Subject: Comments on San Luis Renewable Solar Project Draft EA & FONSI 14-059
SAN LUIS RESERVOIR STATE RECREATION AREA

Response to San Luis and Delta-Mendota Water Authority, January 22, 2016

RE: Comments on Draft Environmental Assessment and Finding of No Significant Impact for the San Luis Solar Project (EA-14-059)

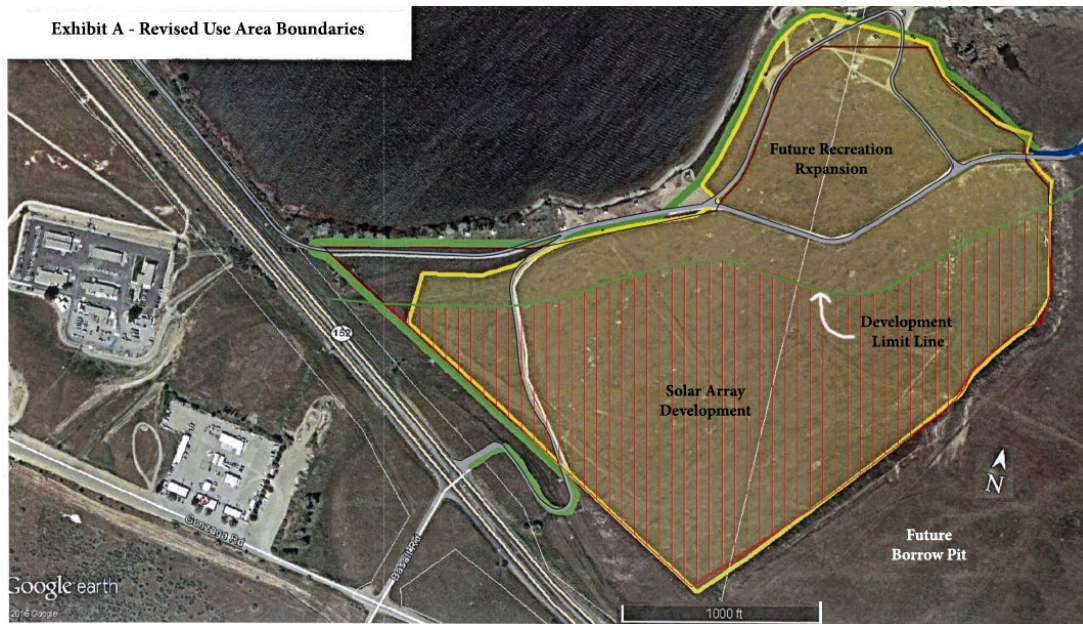
We understand that the State and USBR have an existing 50-year agreement at San Luis Reservoir State Recreation Area, which allows for the maintenance and operation of public recreation, including expansion of shoreline camping and picnic use around the Medeiros Use Area and O'Neill Forebay. However, the USBR proposed construction of a solar array facility close to the Forebay shoreline, complete with perimeter security, eliminates the planned expansion (Exhibit A).

CSPRA-1 The comment states that the “proposed construction of a solar array facility close to the Forebay shoreline, complete with perimeter security, eliminates the planned expansion” of shoreline camping and picnic use in the Medeiros Use Area and O’Neill Forebay.

See Response to CSP-1.

Exhibit B – Showing proposed recreation expansion and State Parks preferred limits of solar array construction (green line) with a 100-yard setback from shoreline USBR Proposal.

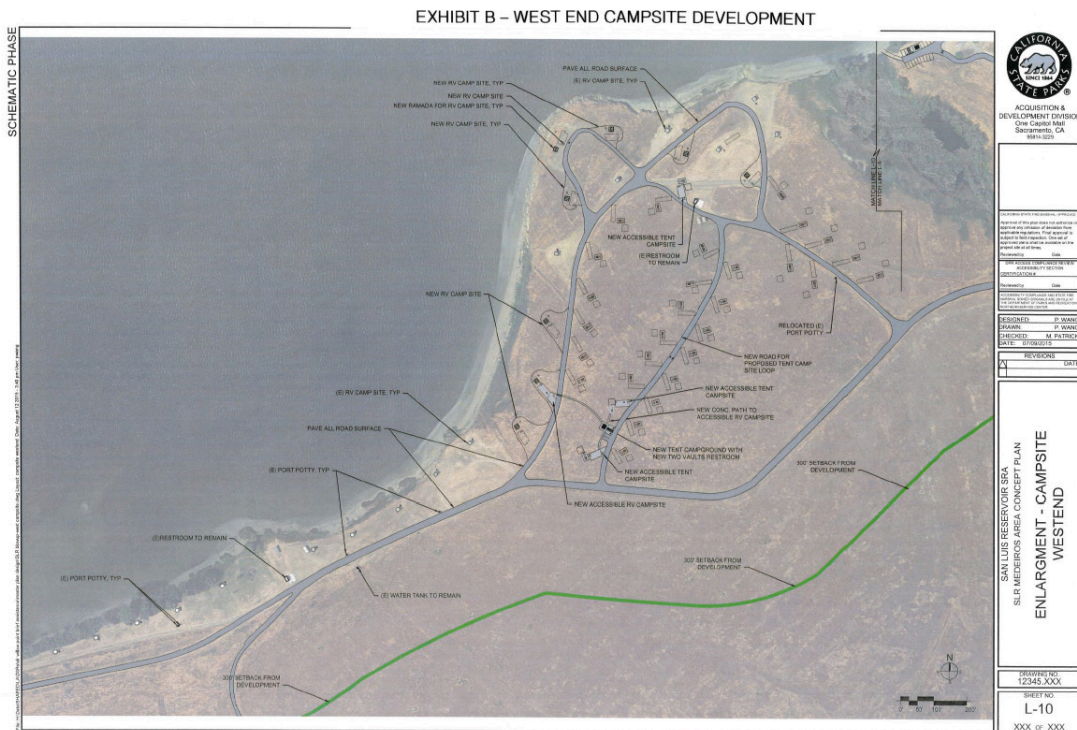
While the project preferred alternative does not appear to impact Biological Resources, it certainly seems to work against the terms of that agreement for recreation, and deprives users of future recreation expansion. Impacts from the development on recreation and public use are not adequately addressed in the Findings. It is impossible to see how USBR project evaluations, which ignore the planned recreational development (see Exhibit B), could result in a finding of no significant impact. USBR's own Mission Statement recognizes the importance of public use, and says the agency, "... has gravitated from development of single-purpose agricultural projects toward a multipurpose approach to water resource development that includes recreation."

CSPRA-2 The comment asserts that the project deprives users of future recreation expansion and that “impacts on recreation and public use are not adequately addressed in the Findings.”

See Response to CSP-3 regarding impacts to Recreation. In reference to the adequacy of Reclamation’s Findings, see Response to GWD-2.
